WOLF TRAILS PARK

Fairfax County Park Authority

MASTER PLAN REPORT

**WOLF TRAILS PARK
PRELIMINARY MASTER PLAN REPORT**

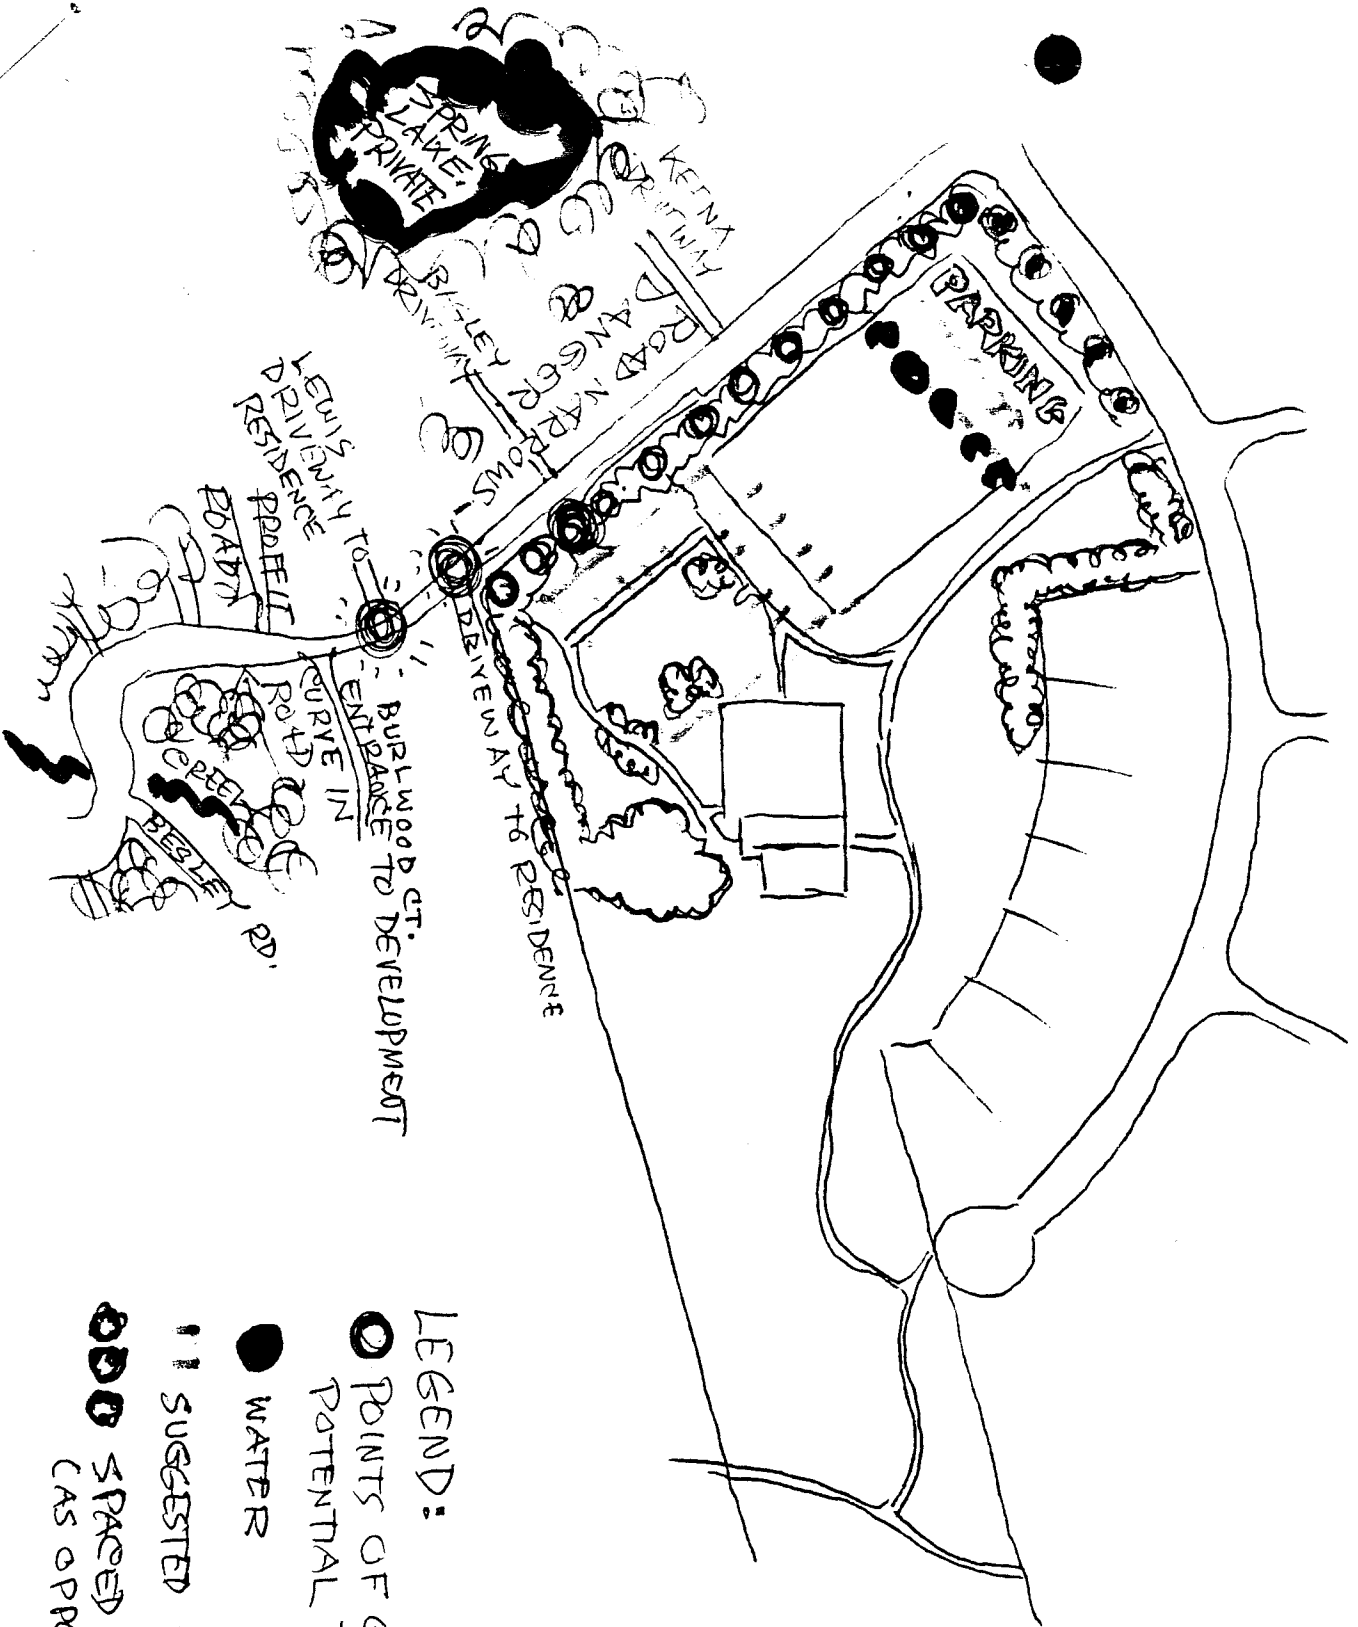
If you will forgive a well-meant intrusion upon your difficult domain, please take a look at the enclosed revised and annotated version of the map of the preliminary master plan. Better still, drop out some day and let me walk over to the site with you if my amateur topography is not clear.
